This ~~Draft-Final~~ Environmental Impact Report (~~DEIR~~FEIR) pertains to the 1,416.5-acre Project Site known as Hoskings Ranch (Proposed Project). The Project Site is located in the unincorporated area of east-central San Diego County, approximately one mile southwest of the unincorporated town of Julian. State Route 78/79, also known as Firefighter Steven Rucker Memorial Highway (SR 78/79), forms its northern boundary, with Pine Hills Road to the east providing the main access route to the Project Site. Figure S-1, "Regional Vicinity Map," shows the Proposed Project's location within the County of San Diego.

A draft version of this EIR was circulated for public review from 08/29/2013 to 10/14/2013. The following is a listing of the names and addresses of persons, organizations, and public agencies that commented during this public review period. They have been designated A through I for ease of reference. This listing is followed by the public comment letters themselves and the responses to those letters.

Hoskings Ranch: Draft Response to Comments

Figure 2-3-3

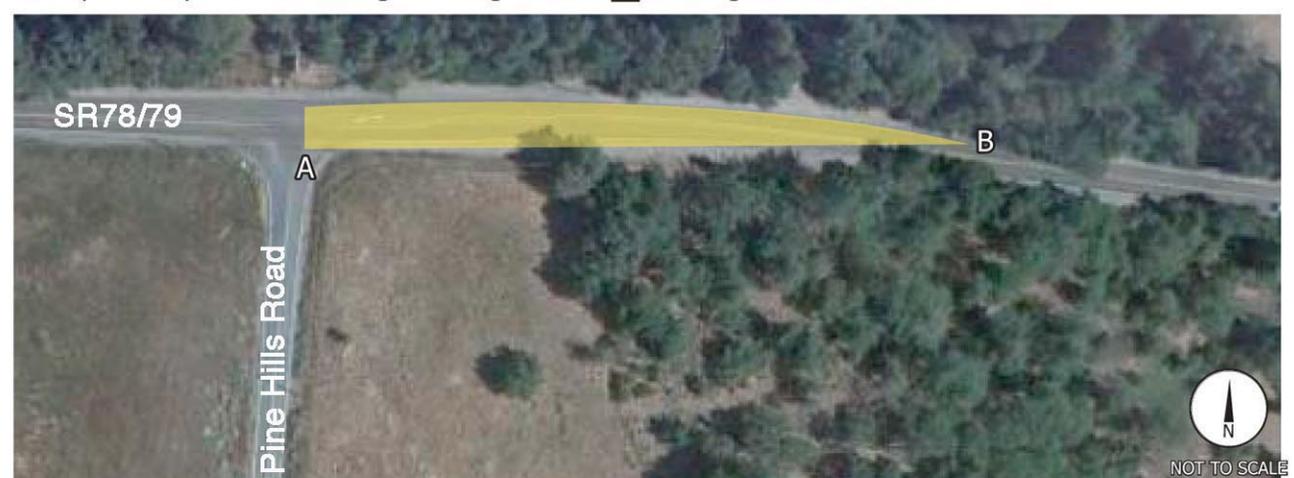
- Summary**
 - Caltrans uses HDM for sight distance analysis on state highways. Please resubmit sight distance using HDM standards. 13
 - Please verify how tree removal will mitigate sight distance based on HDM standards. 14

Two intersections movements were found to lack adequate corner sight distance, as shown in TIS Table 5-1 (Attachment B). These are: (1) when northbound traffic on Pine Hills Road stops at the SR 78/79 intersection before making a left turn, corner sight distance looking right toward Julian is 535 feet. The optimal distance is conservatively 660 feet. (2) When eastbound traffic on Tenaya Road (the proposed entry road) stops at the Pine Hills Road intersection before making a turn, sight distance looking left is 400 feet. The optimal distance is conservatively 550 feet. To correct these deficiencies the TIS (page 39) and the EIR (Section 2.3.2.5, page 2-45) call for vegetation trimming or removal. This action is proposed as part of the project design. EIR Figure 2-3-3, "Sight Distance Constraints," included in Attachment B, was developed to assess the scope of the corner sight distance deficiencies. In the figure a signman has been located at the conservative distance and photos have been taken from the constrained vantage points. In all cases the signman is visible without recourse to vegetation removal. However, to maintain a conservative analysis, the project requires an assessment of these vantages and trimming or removal of the vegetation as needed.

13. Sight distance has been calculated by KOA Corporation using Caltrans HDM sight distance standards, as detailed in Response 2 above. Please see photo exhibits included in Attachments A and B showing sight visibility for the various project intersections.

Figure 1-4
Project Trip Distribution

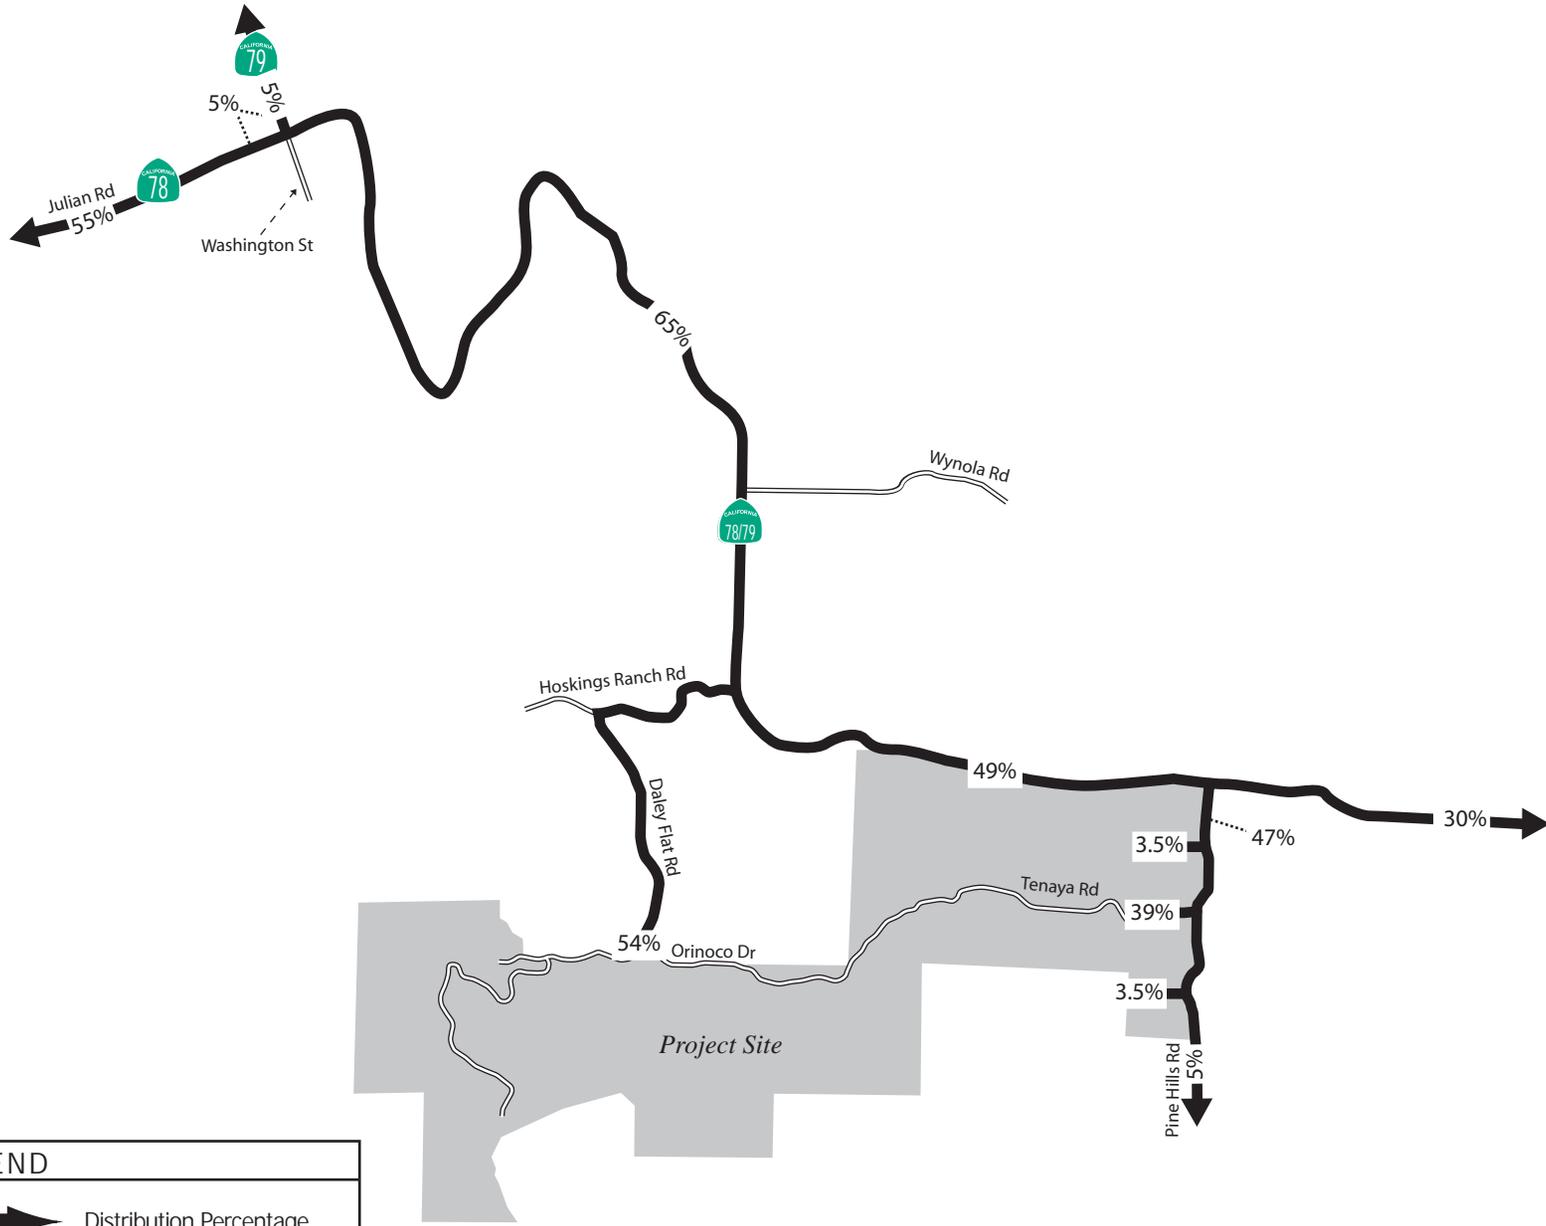
- Please verify the type of heavy vehicles that will access the site for agricultural purposes. 15
 - Caltrans recommends channelization at the intersections of Hoskings Ranch Road and Pine Valley Road on SR-78/79 for operational and safety reasons due to the high speeds of the facility, speed differentials of vehicles slowing down at the intersections, as well as the introduction of heavy vehicles for agricultural purposes. 16

5. The information referenced in the comment is provided in the TIS (EIR Appendix D). (For convenience these graphics are also attached to this response as Attachment D).

- a. Table 1-1, Project Rip Generation, TIS page 3
 - b. Figure 1-4, Project Rip Distribution, TIS page 7
 - c. Figure 1-7, Project AM Peak Hour Trips, TIS page 10
